REZONING SITE PLAN

ZONING COMMENTS:

Z-18 POPE & LAND ENTERPRISES, INC.

Application No. Z- 18
(2016)

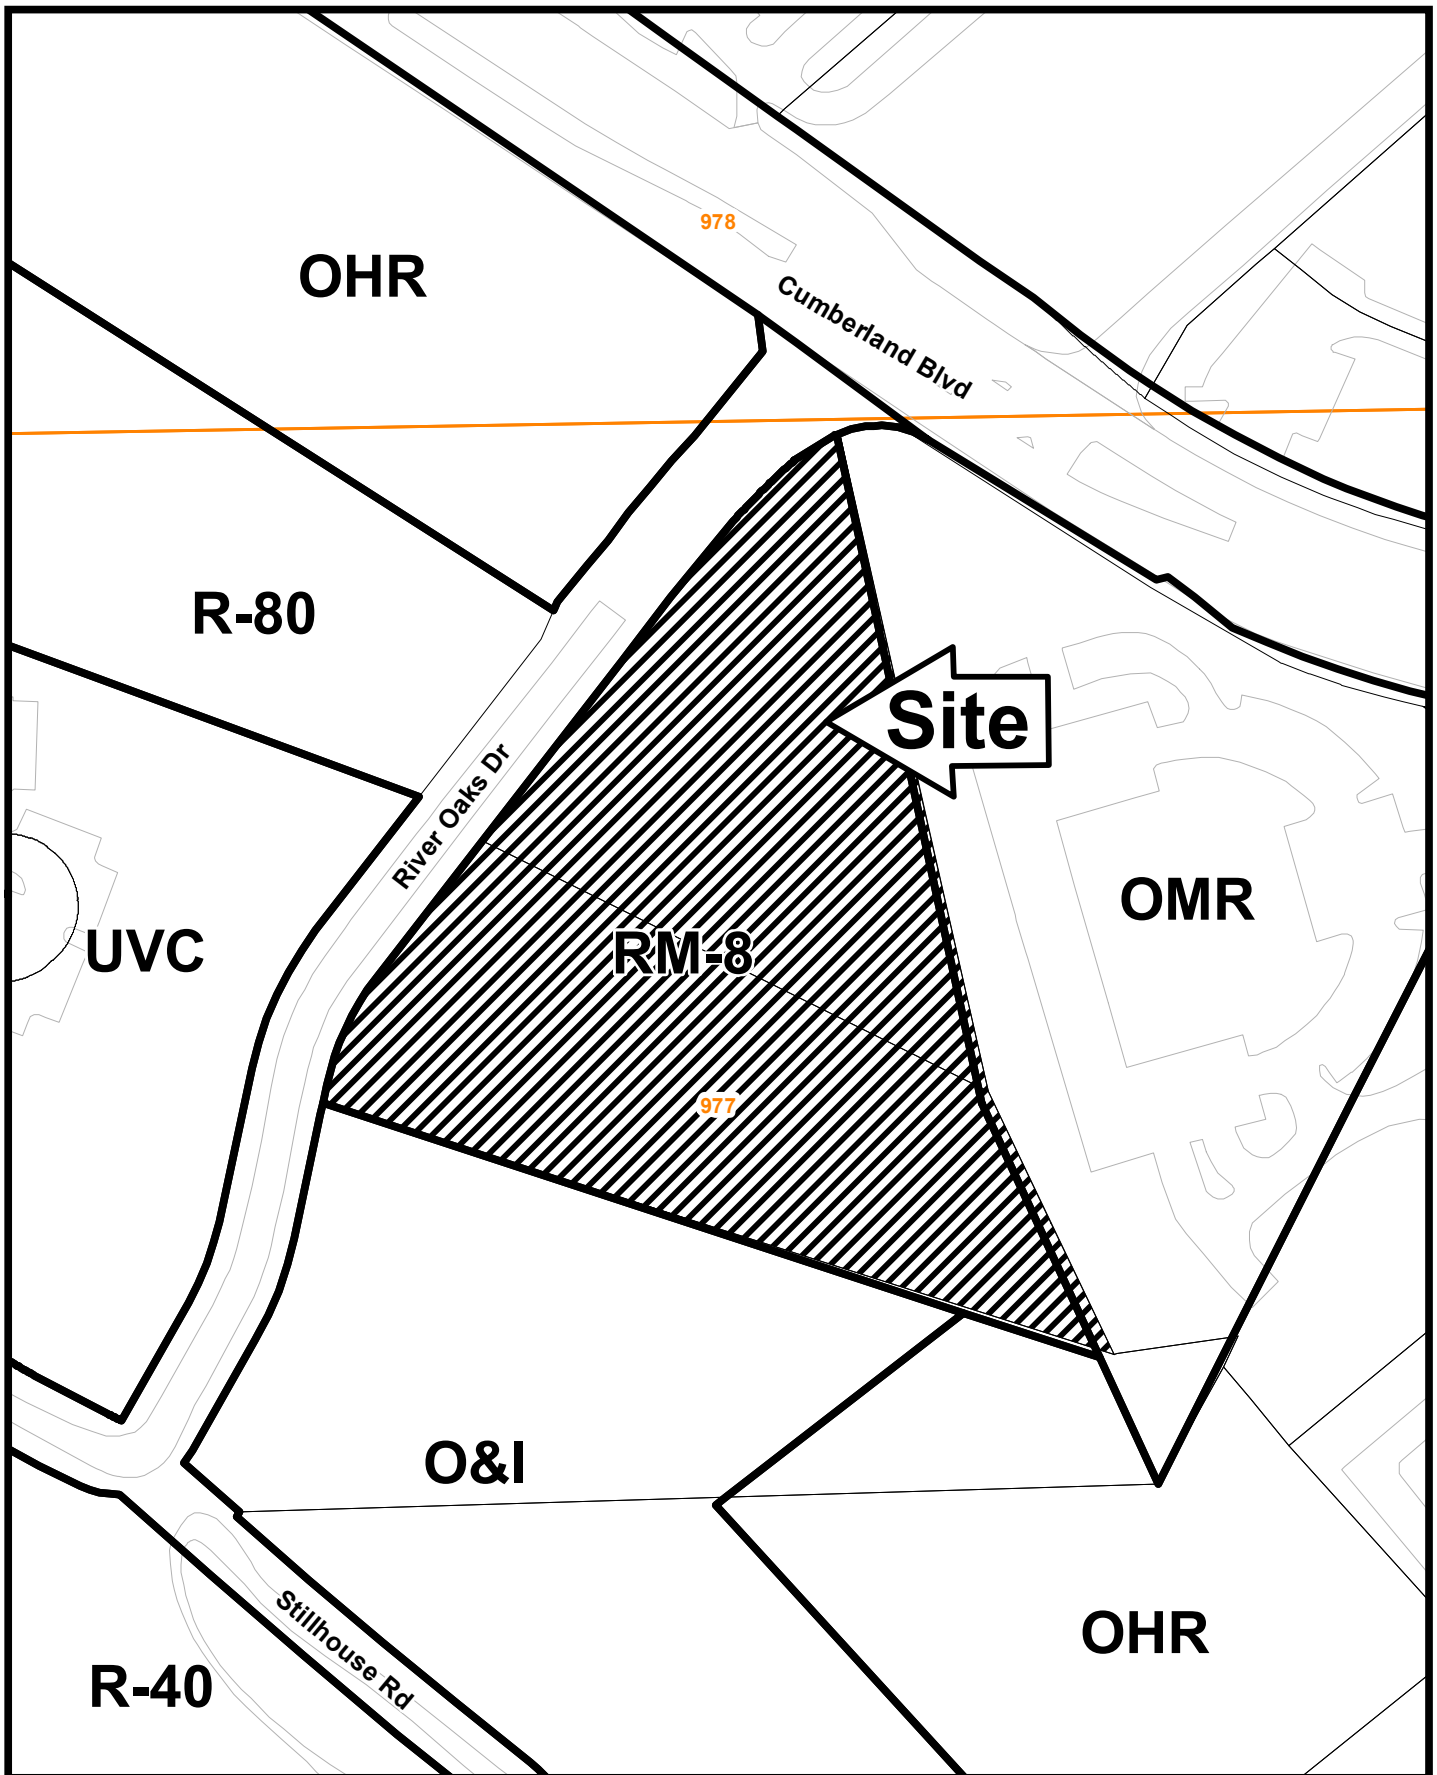
- Provide comprehensive hydrology/stormwater controls to include development of out parcels.
- Submit all proposed site improvements to Plan Review.
- Any **spring activity** uncovered must be addressed by a qualified geotechnical engineer (PE).
- Structural fill _____ must be placed under the direction of a qualified registered Georgia geotechnical engineer (PE).
- Existing facility.
- Project must comply with the Water Quality requirements of the CWA-NPDES-NPS Permit and County Water Quality Ordinance.
- Water Quality/Quantity contributions of the existing lake/pond on site must be continued as baseline conditions into proposed project.
- Calculate and provide % impervious of project site.
- Revisit design; reduce pavement area to reduce runoff and pollution.

- No Stormwater controls shown _____
- Copy of survey is not current – Additional comments may be forthcoming when current site conditions are exposed.
- No site improvements showing on exhibit.

The site roadway configuration and retaining wall located in the right-of-way do not meet Cobb DOT standards.

The site roadway configuration and retaining wall do not meet Cobb County DOT standards. Recommend roadway design and retaining wall details to be determined during plan review, subject to Cobb County DOT approval.
